PROJECT: **Cowichan Secondary Watermain Extension – Canada Avenue to Duncan Street - Tender**

FILE NO: 2233-02091-00

Addendum #1

ISSUED FOR ADDENDUM #1

CONNECTION DETAIL B
SCALE: NTS

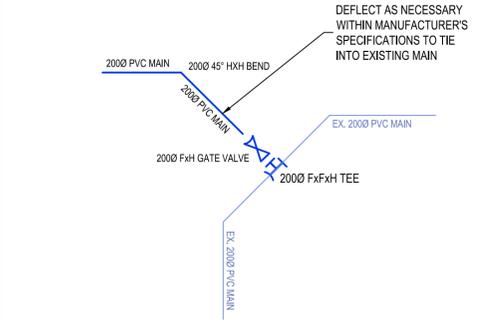
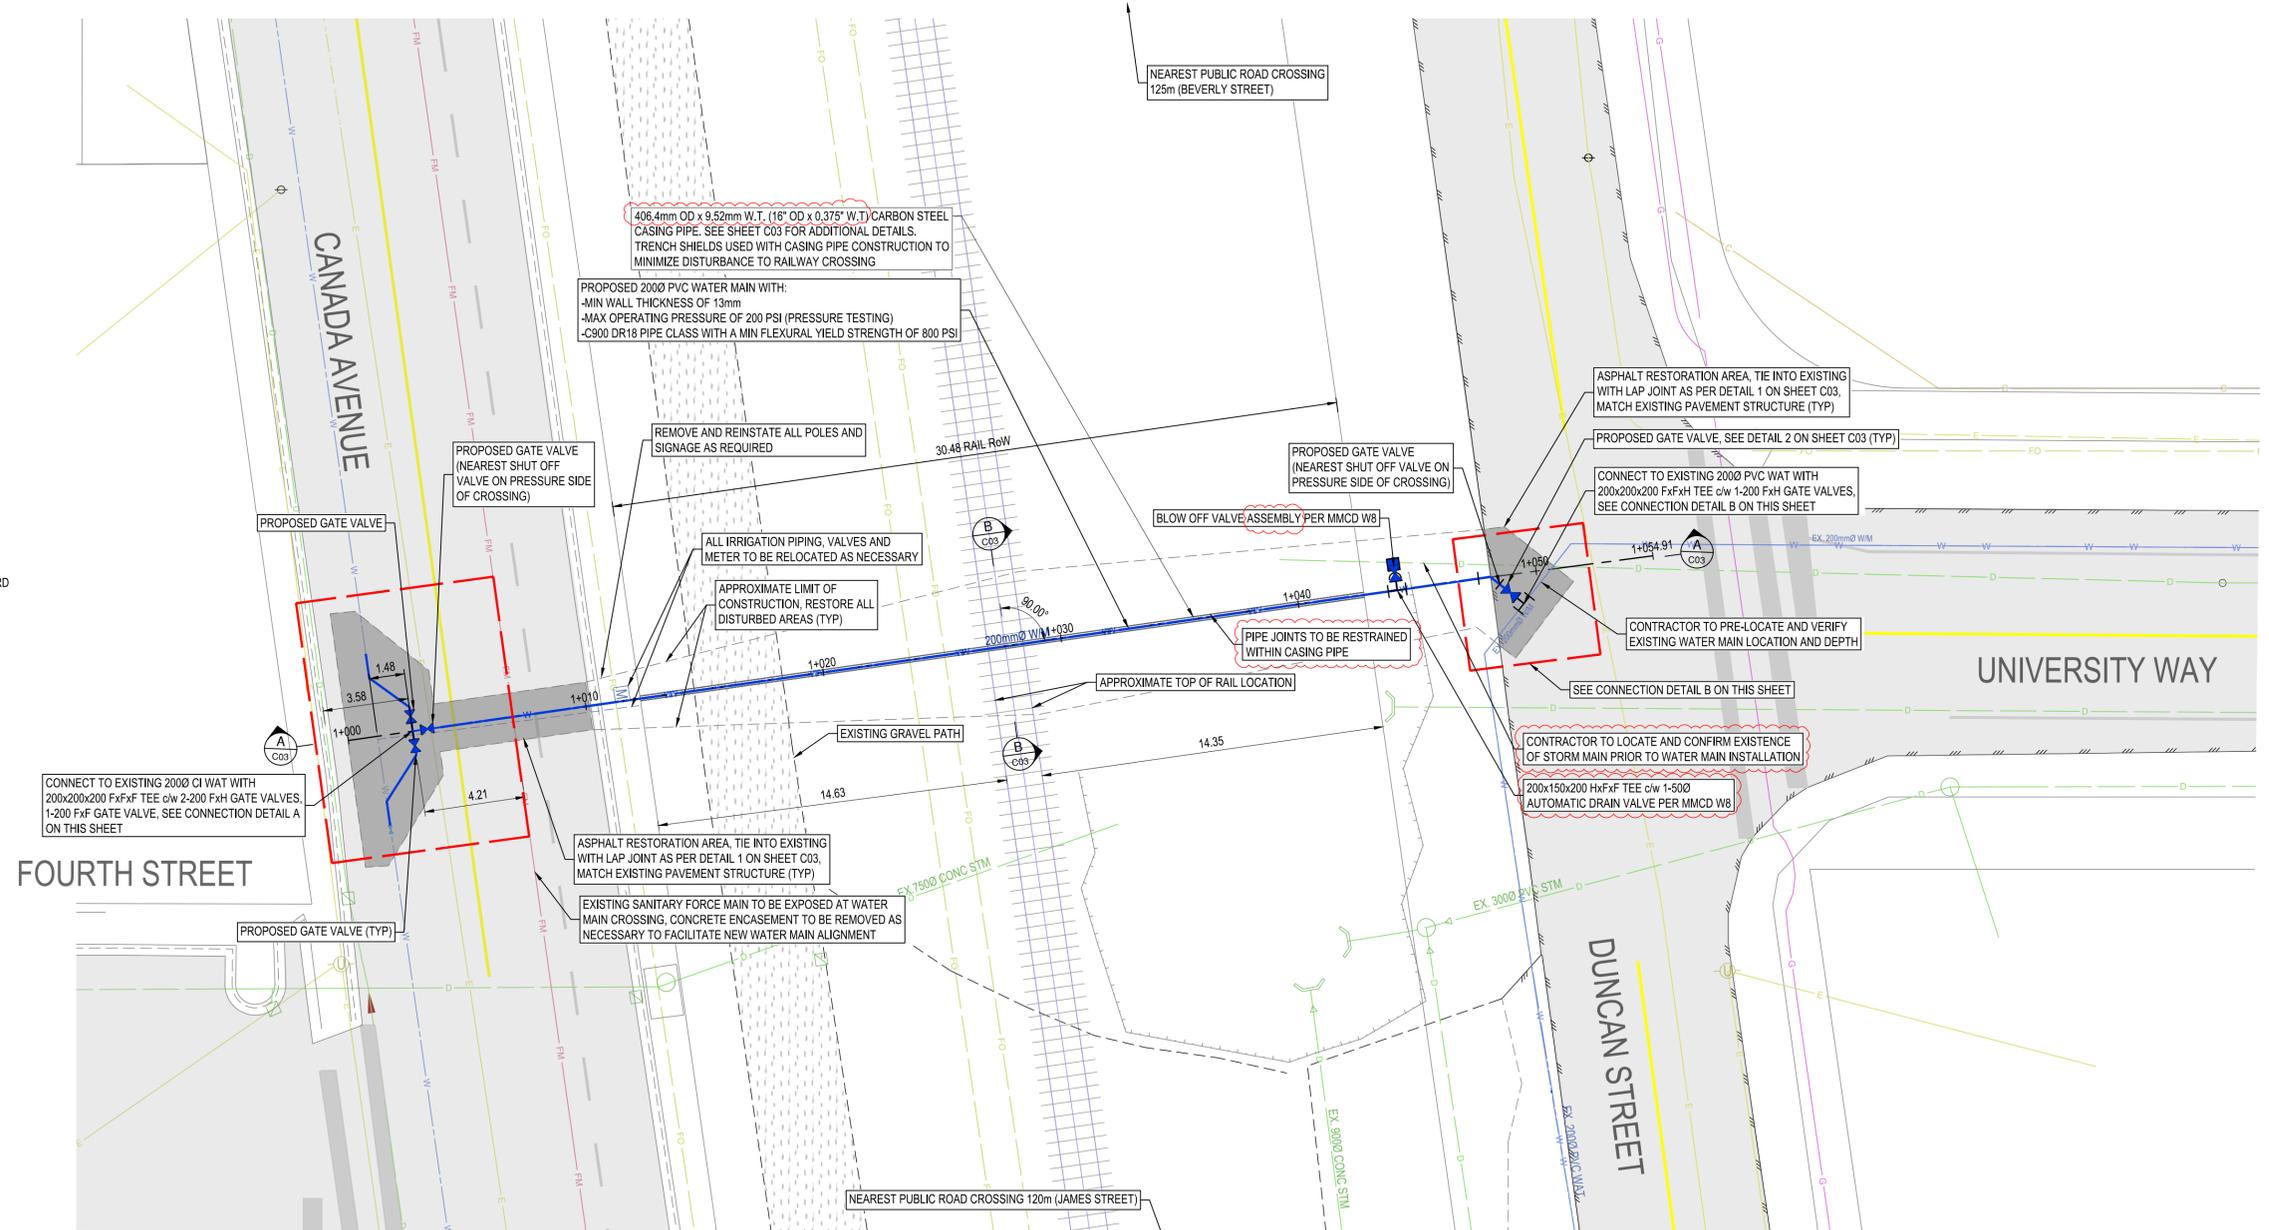
- e. Note 3 under watermain mentions joint restraints; is that for all joints or just at bends? We are also wondering if the joints within the steel casing need to be restrained? If so, the C900 pipe with restraints may be too tight to fit within the 12" steel casing.

- i. Please provide a connection detail for the blow off valve. Drawings show a Blow off valve per MMCD W8, but this detail is for a blow off valve at the end of a line.

- i. **Joint restraints will be required within the casing pipe and at bends and hub fittings. See revised Contract Drawings with updated material specifications.**

- i. **See revised Contract Drawings appended to this addendum, with clarification regarding the required tee assembly.**
- j. Per item 32.02 – Permanent painted pavement markings; Please confirm if this item is for Thermoplastic or Paint

B
C02
TYPICAL RAIL CROSSING
SCALE: H:NTS
V:NTS

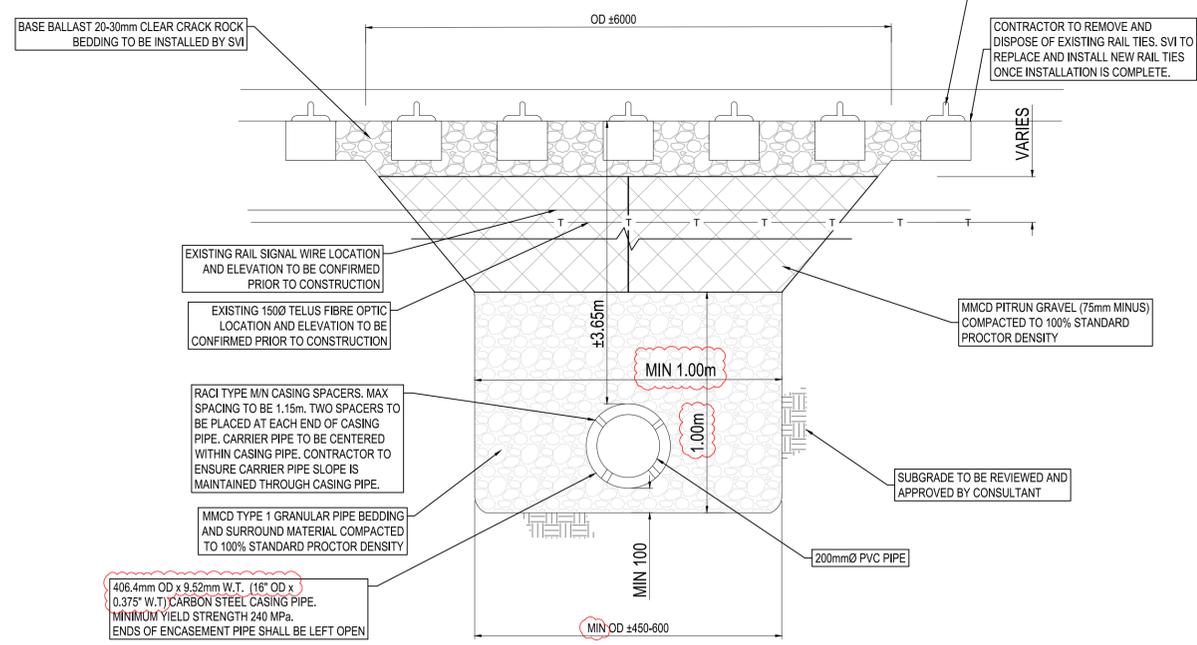
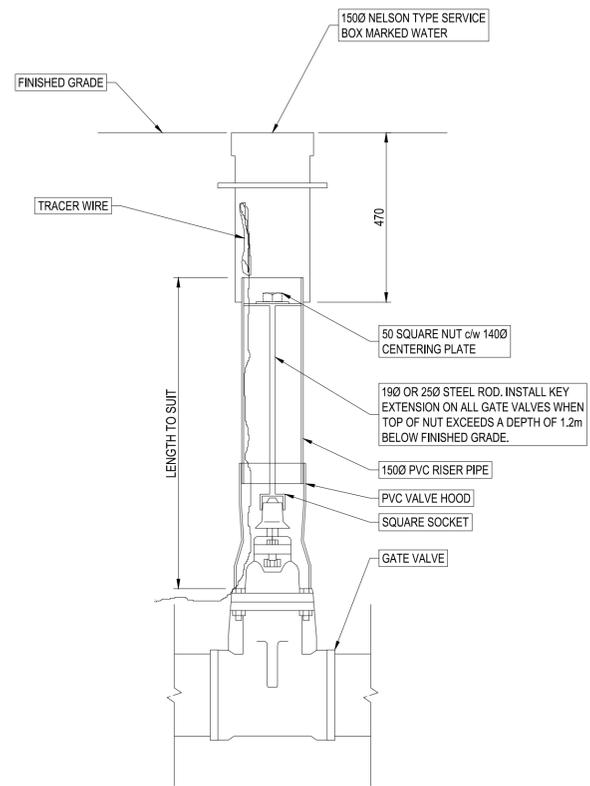
- g. Typical Rail Crossing detail B on drawing C03, the specified bottom trench width is not possible when pulling a cage/trench shield.
 - i. **Please assume a widened trench width as required for the construction methodology, meeting the minimum dimensions provided in the detail. See revised Contract Drawings appended to this addendum.**

- l. Regarding the casing pipe, our suppliers have informed us that the casing size is not large enough to allow room for the casing spacers around the 200mm C-900 pipe. Suppliers recommend 16" O.D. for the casing pipe. Please confirm the size of casing pipe to price.

- i. **The encasement pipe sizing has been increased in the revised Contract Drawings appended to this addendum.**
- m. Please confirm that the contractor will not be responsible for the removal and re-installation of the railway tracks including ballast rock.

- i. **As per Contract Drawings, Sheet C03 Detail B, track removal and reinstatement, and ballast rock reinstatement will be completed by SVI at the City's cost. Existing ballast and rail tie removal and disposal to be completed by Contractor.**
